ADMINISTRATIVE DECISION - MINOR HISTORIC REVIEW

CASE NO. Historic Review Case HIS15-38 / Amanda No. 15-116748-DR

REQUEST: Minor Administrative Review of a proposal to install two new condenser units, a new rooftop kitchen hood exhaust fan and one new makeup air unit on the roof of the Grand Theater Building (1900), a contributing resource within the Salem Downtown National Register Historic District, zoned CB (Central Business District) zone, and located at 187-195 High Street NE, 97301. (Marion County Assessor's Map and tax lot number: 073W27AB90000).

Approximate location of new condensing units

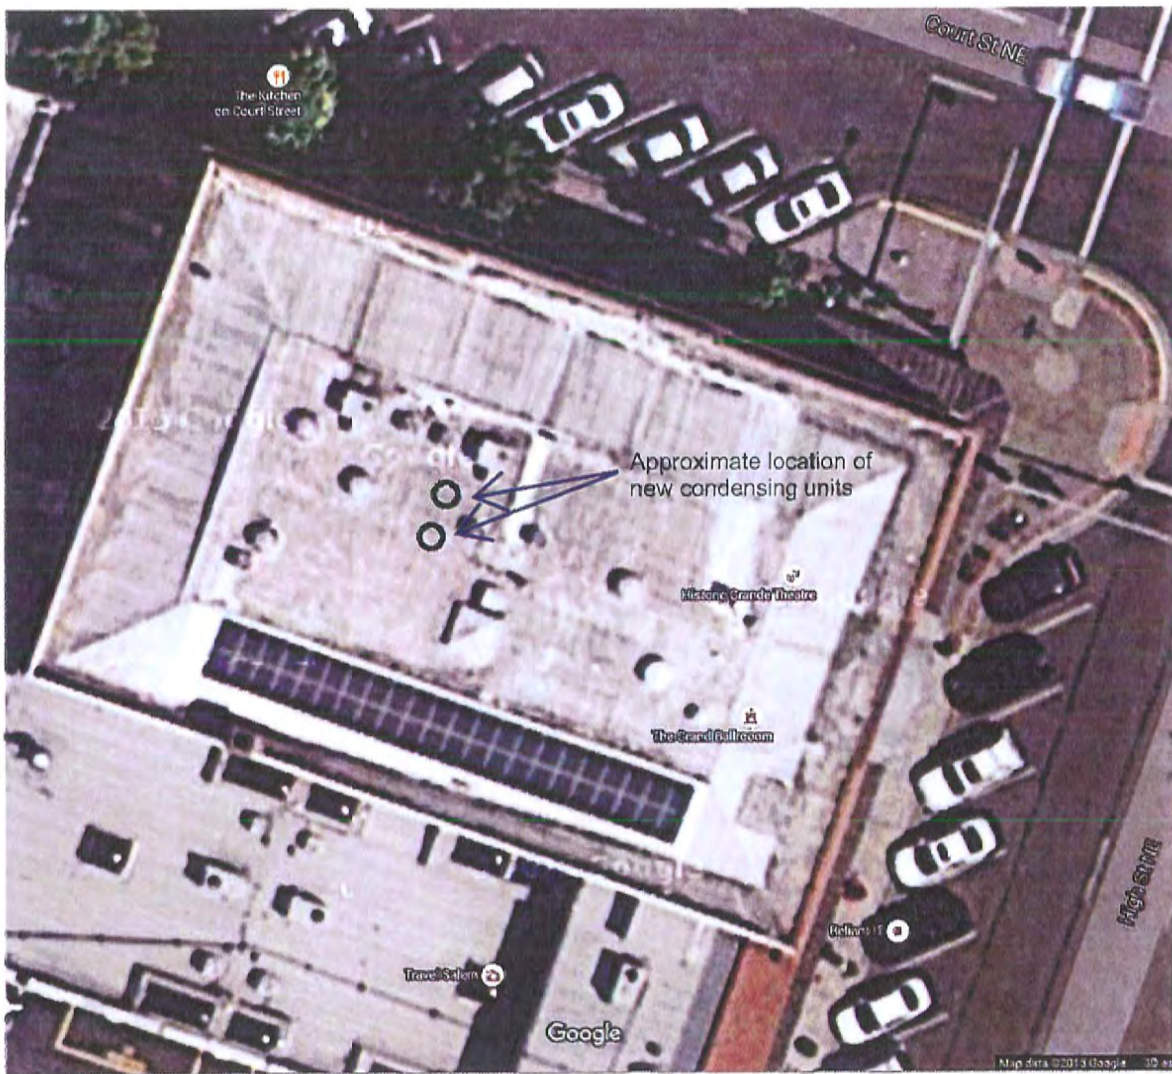
Finding: The proposed HVAC units will be located toward the center of the roof of the Grand Theater Building, not visible from the public right of way thereby meeting SRC 230.040(j)(2)(A).

Finding: The proposed HVAC units will be recessed toward the center of the roof between 25' and 40' from the roof parapet of the Grand Theater Building, not visible from the public right of way thereby meeting SRC 230.040(j)(2)(B).

Finding: The proposed HVAC units are low profile, between 37 ¼" and 44" in height, recessed toward the center of the roof of the Grand Theater Building, not visible from the public right of way thereby meeting SRC 230.040(j)(2)(C).
